ADDENDUM NO. 4

Reference: Gibson Science Center Addition
Southern Utah University – Cedar City, Utah
DFCM Project No. 07297730

Subject: **Addendum No. 4**

Sheet No.
AD04-C7
 Sheet Reference
 CE104

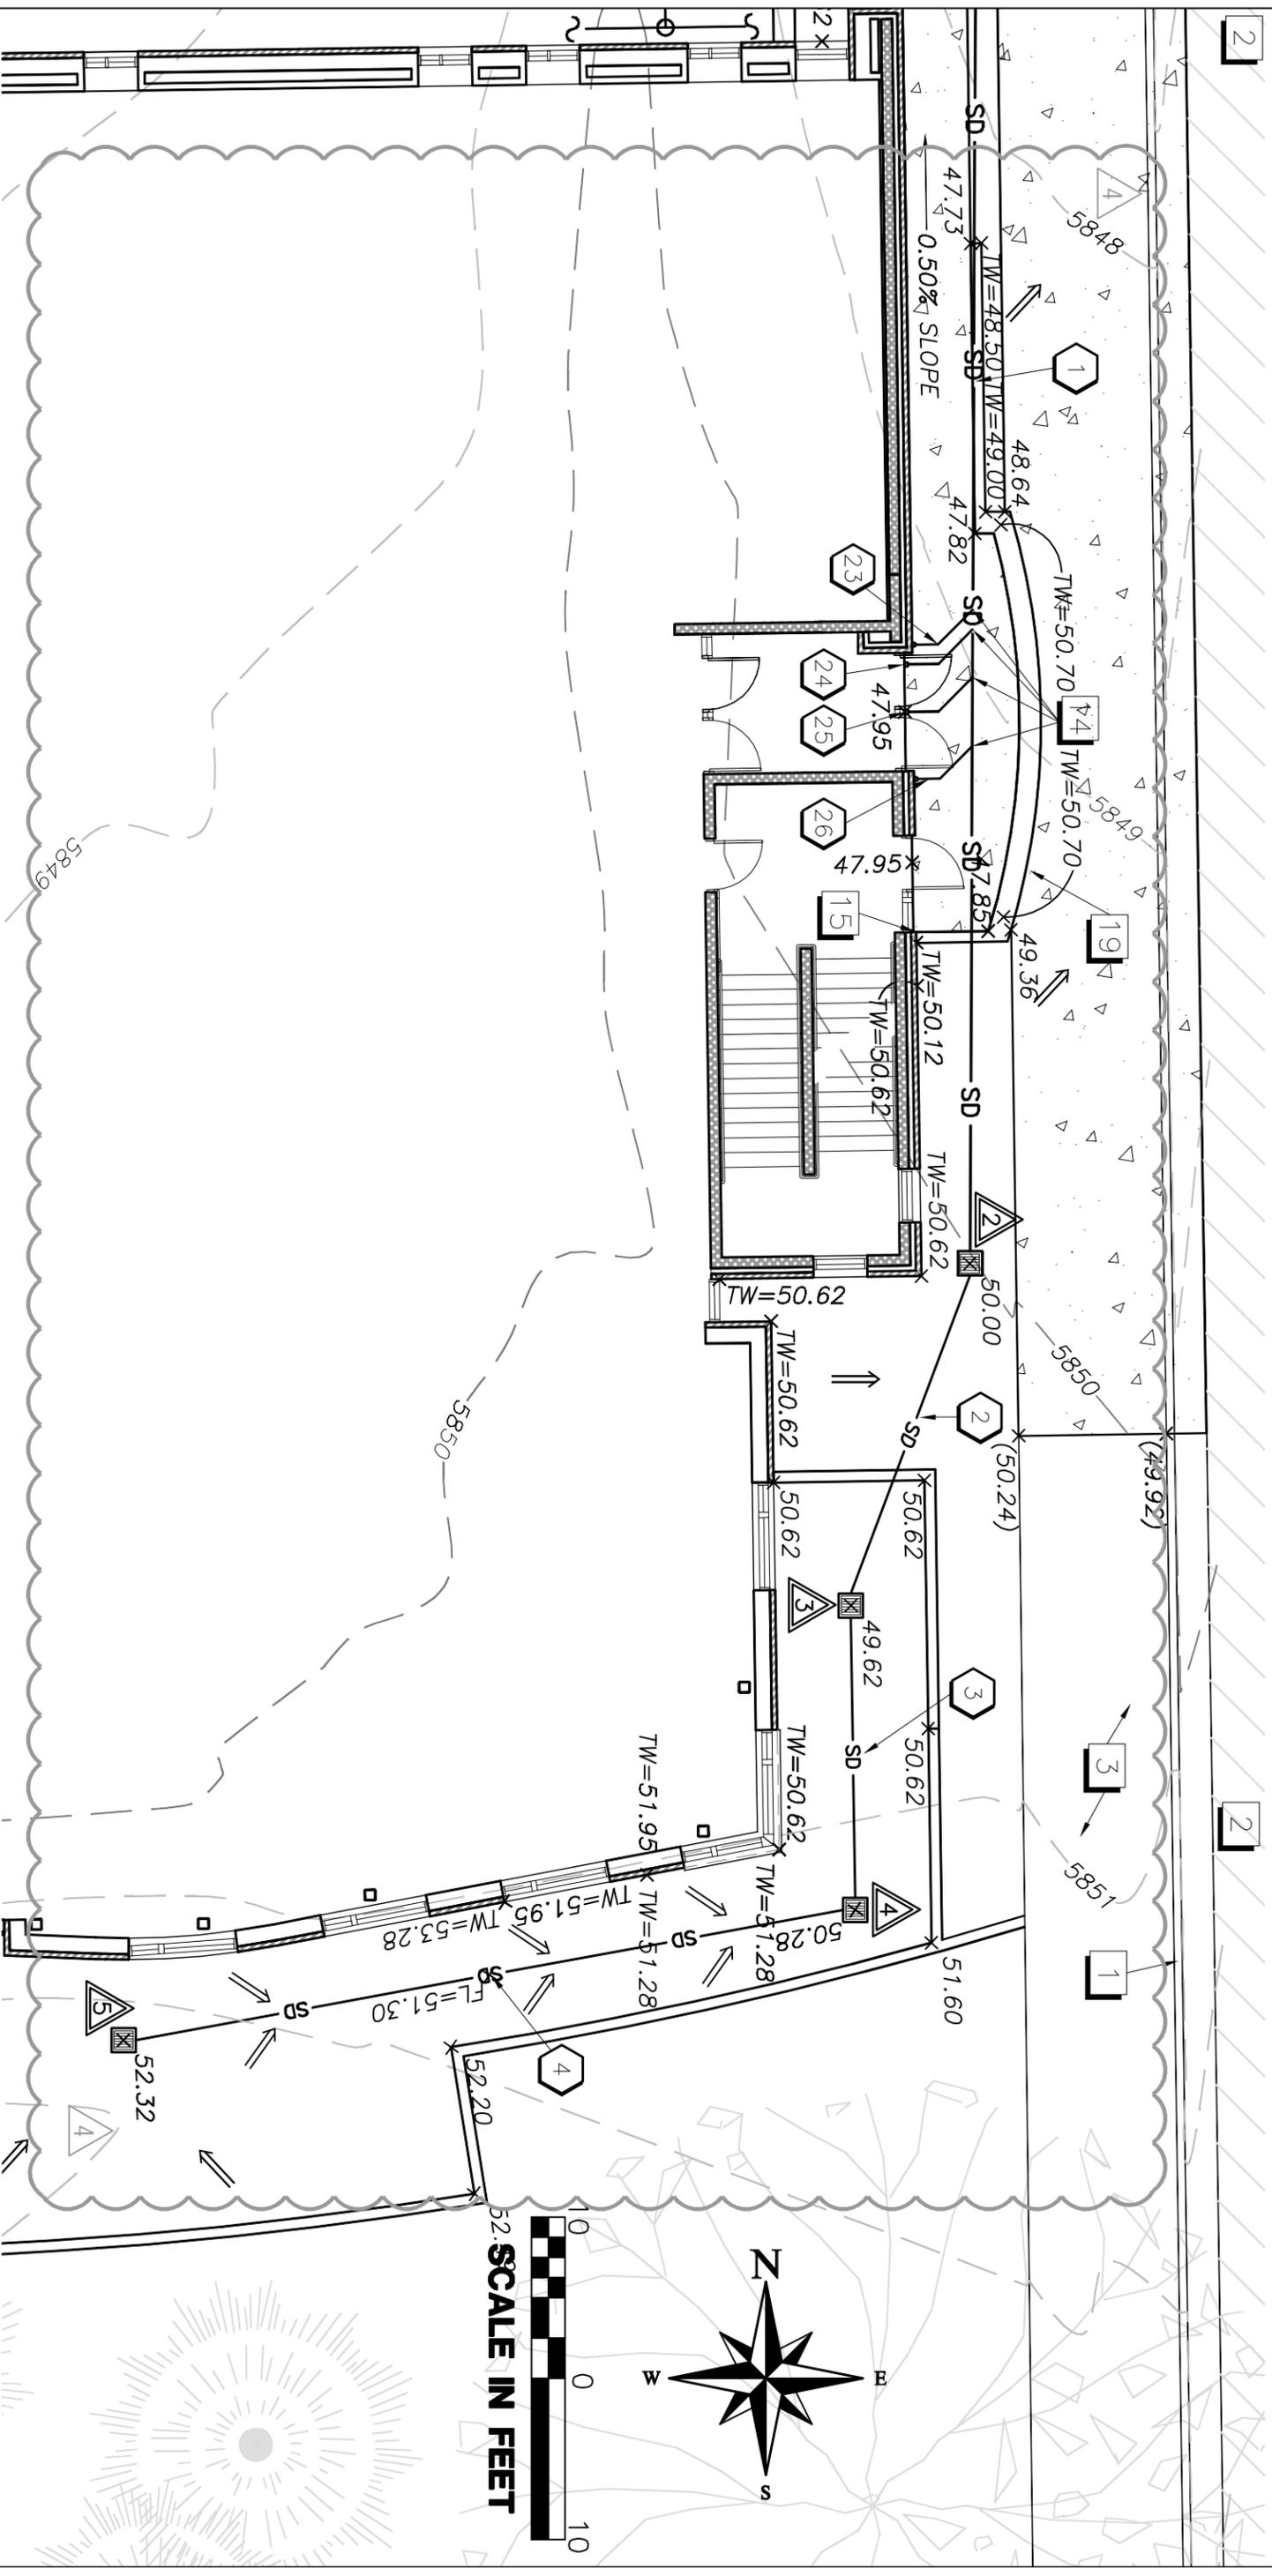
- C1.4** The storm drain lines on the south side of the building were modified to take runoff from the south side to the west storm drain line. See attachments AD04-C4 through C8 and Sheet CE 104.

Sheet No.
AD04-SS03
 Sheet Reference
 SB601

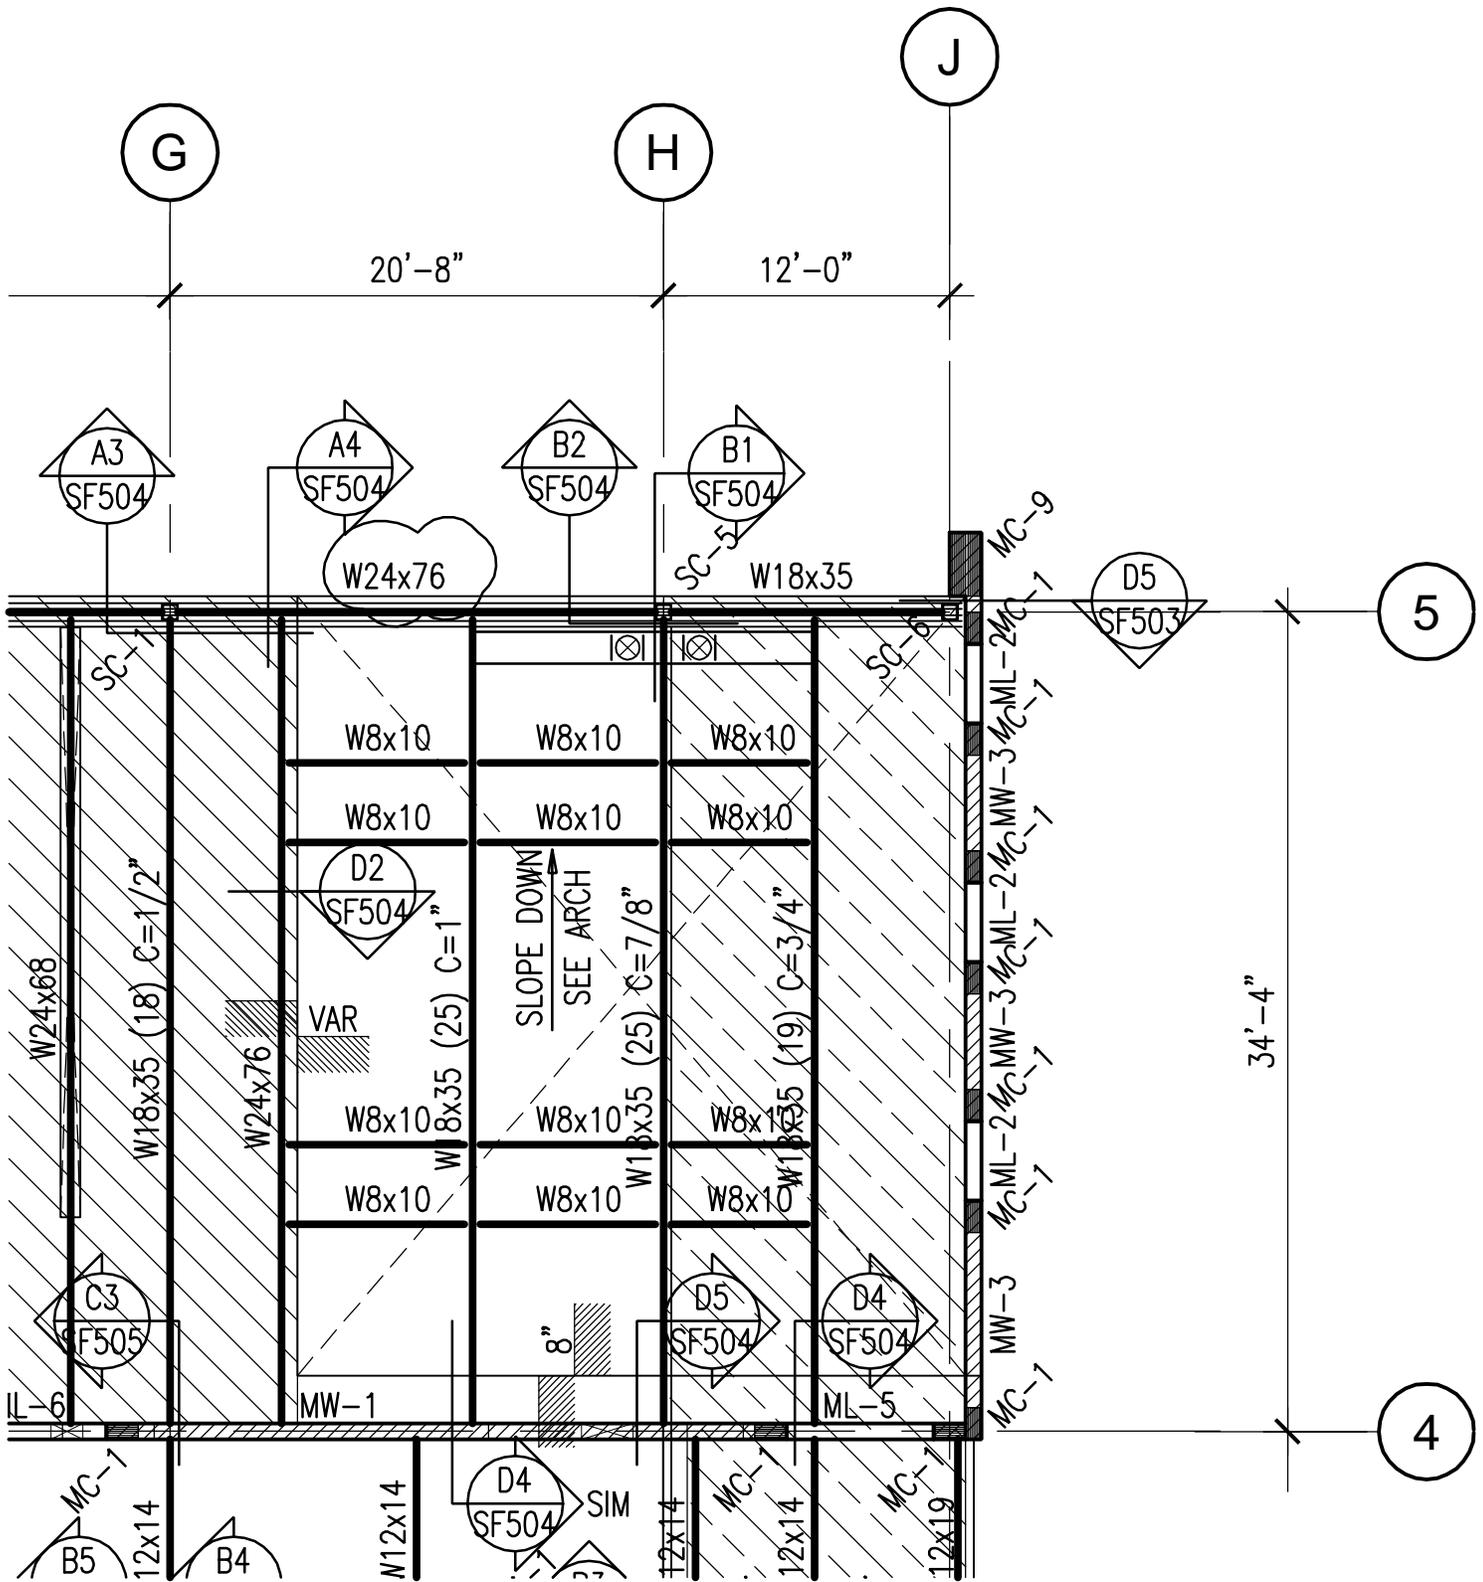
- S1.4 Re: SB601: .CGB-1 revised and CGB-4 added to CONCRETE GRADE BEAM SCHEDULE. Drawing AD04-SS03 attached.
- S1.5 Re: SF101: Add detail cut A4/SF506 Typ./Sim. Drawing AD04-SS09 attached

Sheet No.
AD04-SS04
 Sheet Reference
 SF103

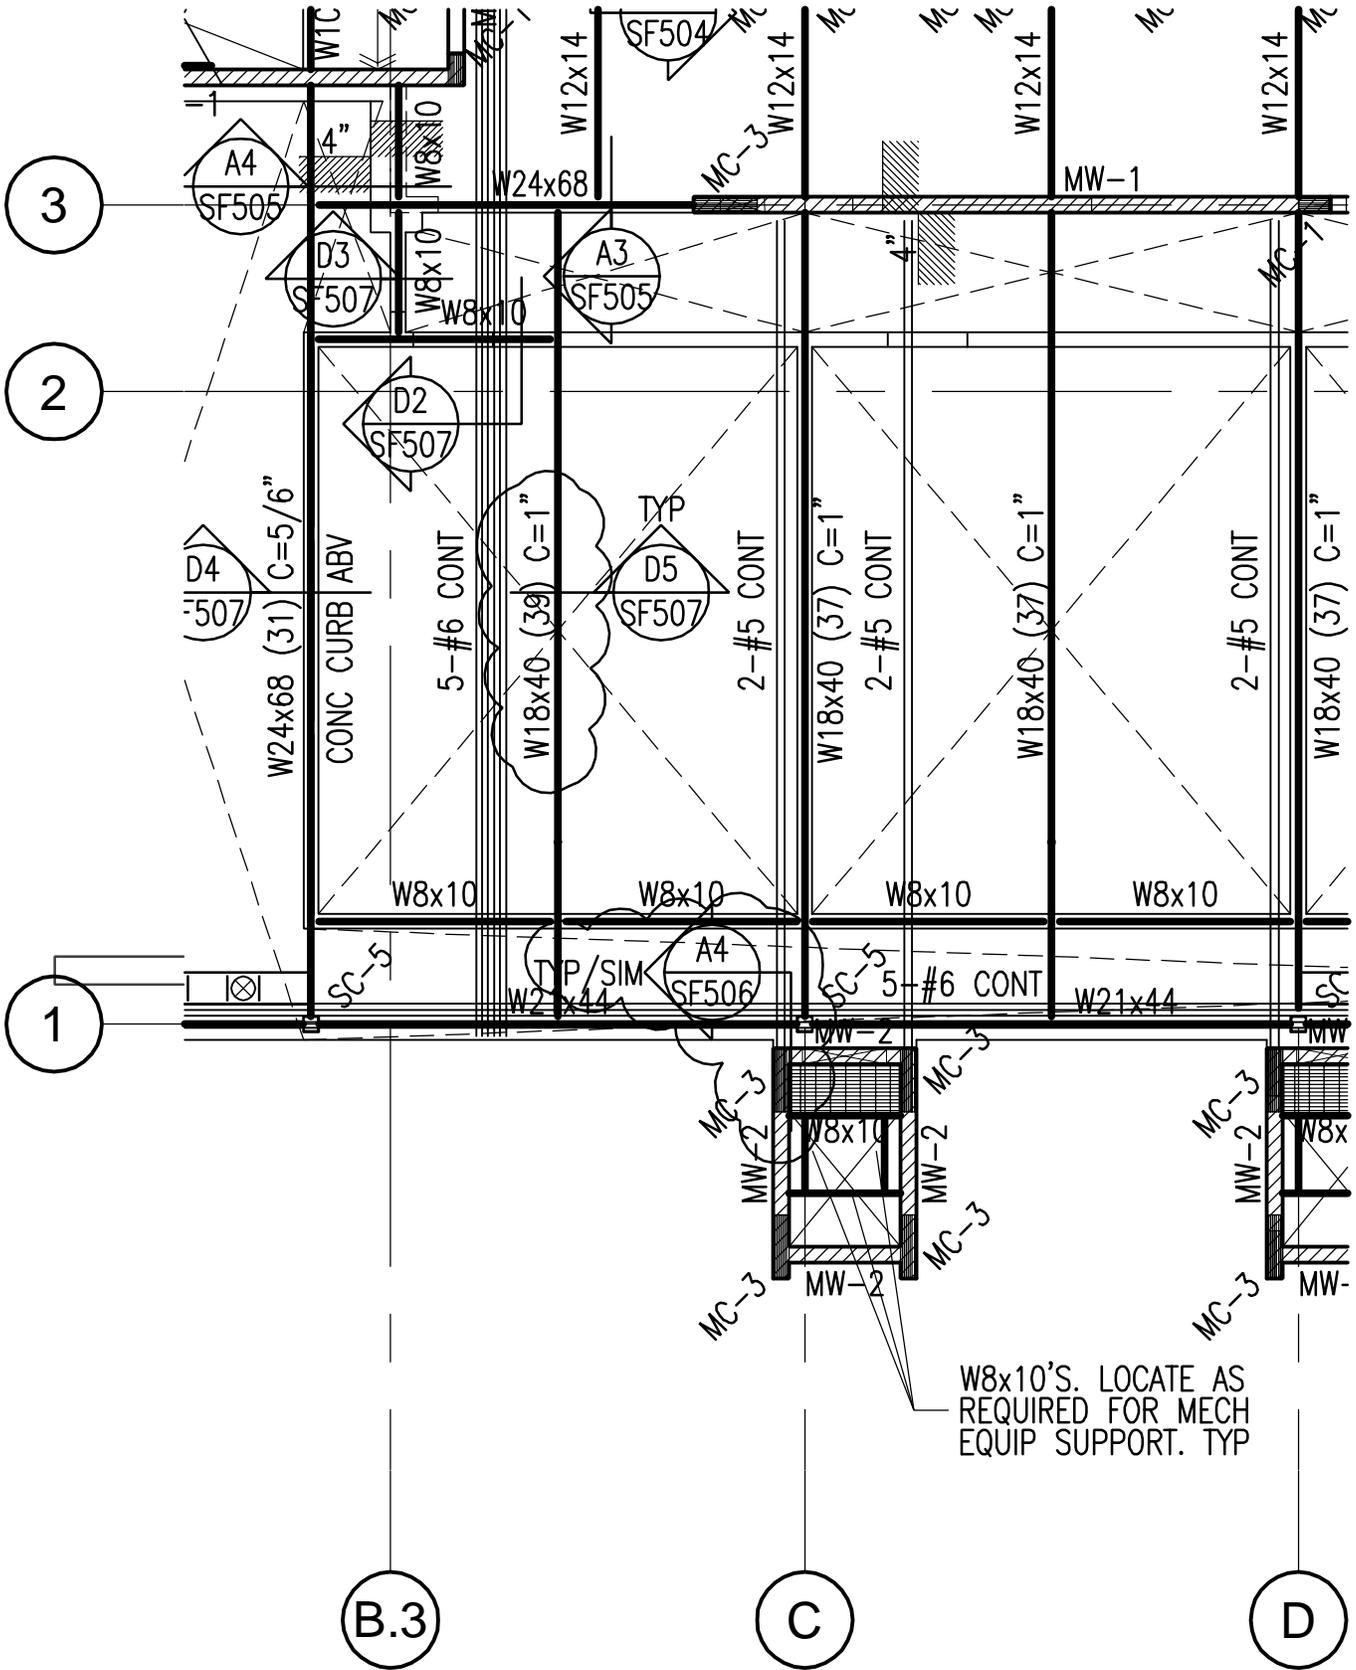
- S1.8 Re: SF103: Beam size changed for beam on grid 5 and between grids G and H. Drawing AD04-SS04 attached.
- S1.9 Re: SF103: Beam size changed for beam near grid B.3 and between grids 1 and 3. Drawing AD04-SS05 attached.

Sheet No.
AD04-SS08
 Sheet Reference
 SF102

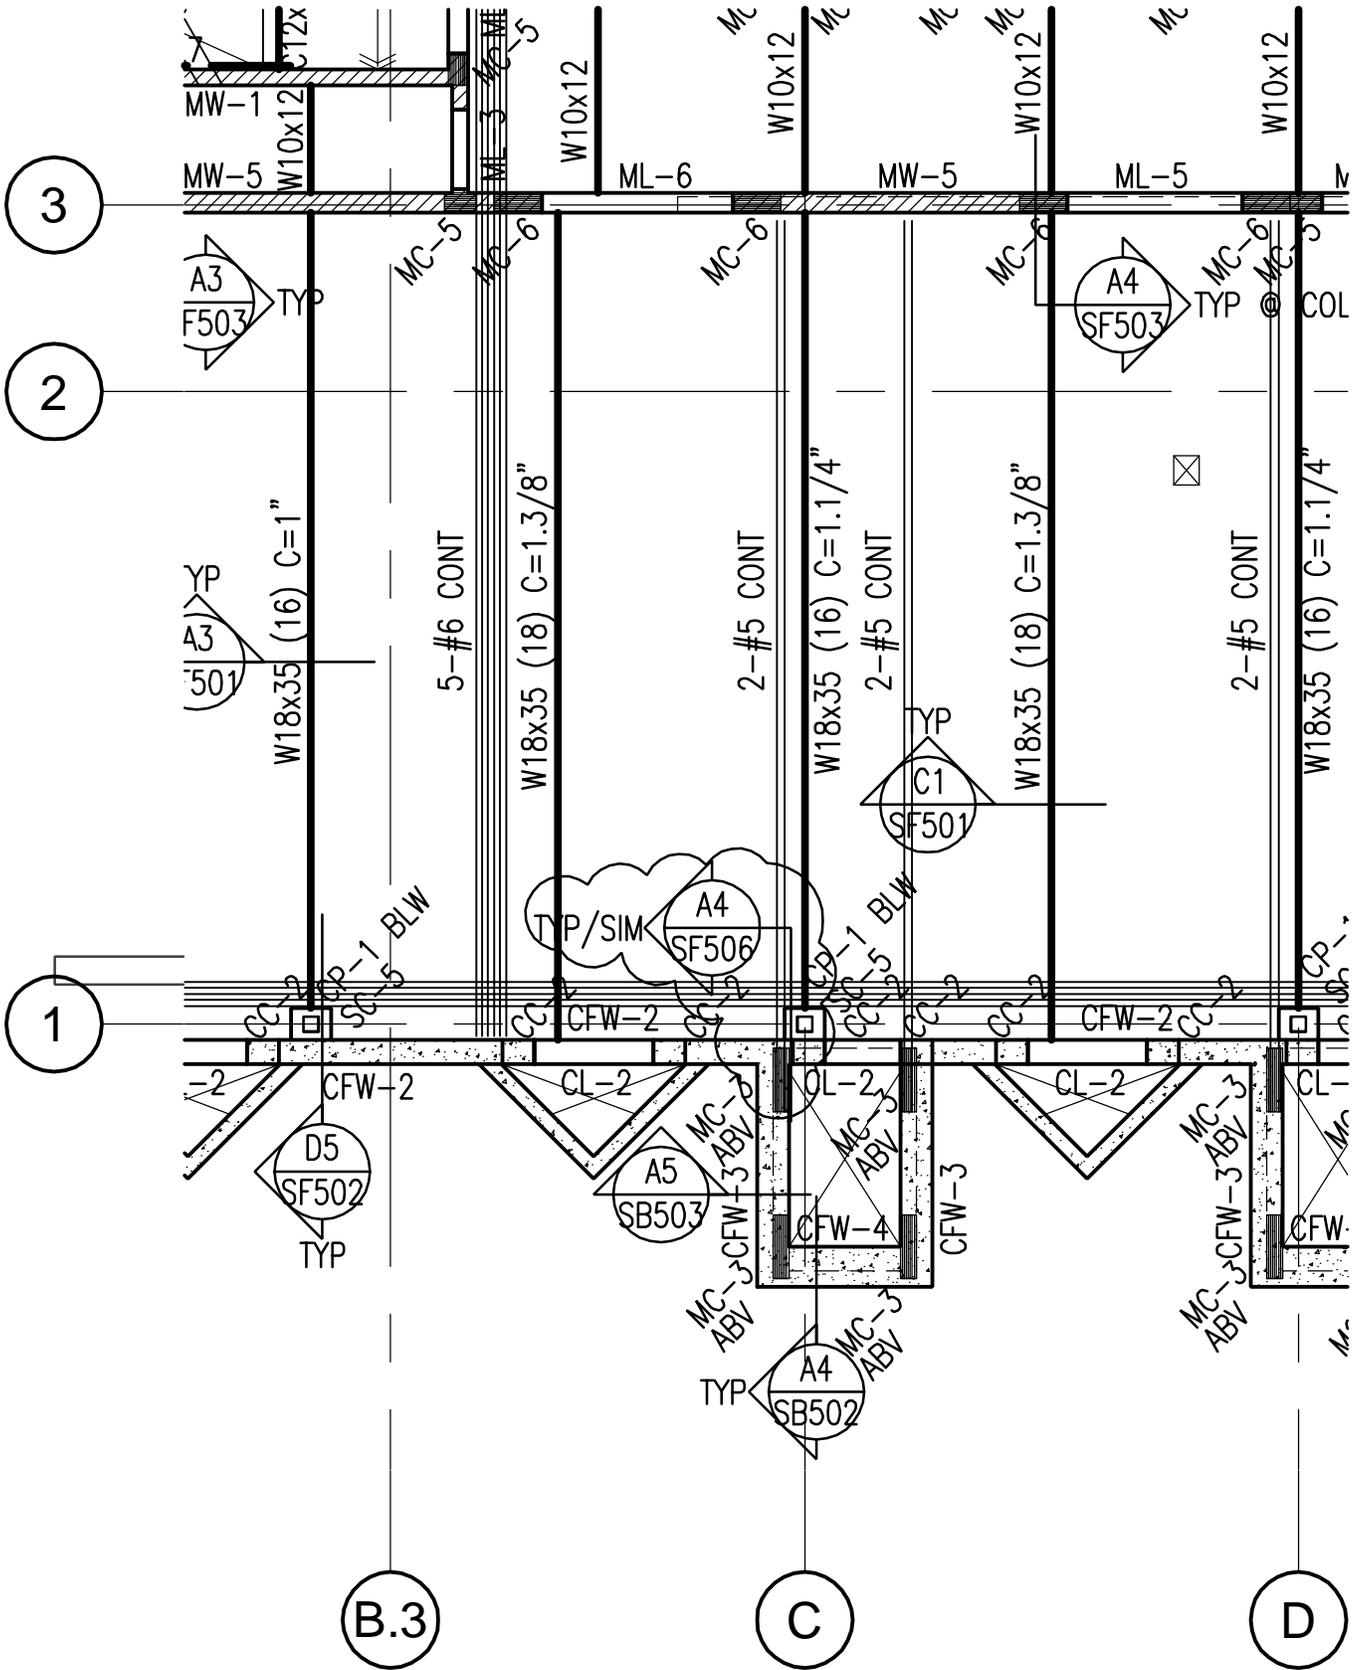
- S1.6 Re: SF101: Revised footing mark to CGB-4 for footing below screenwall located near grid J and above grid 5. Drawings AD04-SS12 attached.
- S1.7 Re: SF102: Add detail cut A4/SF506 Typ. Drawing AD04-SS08 attached
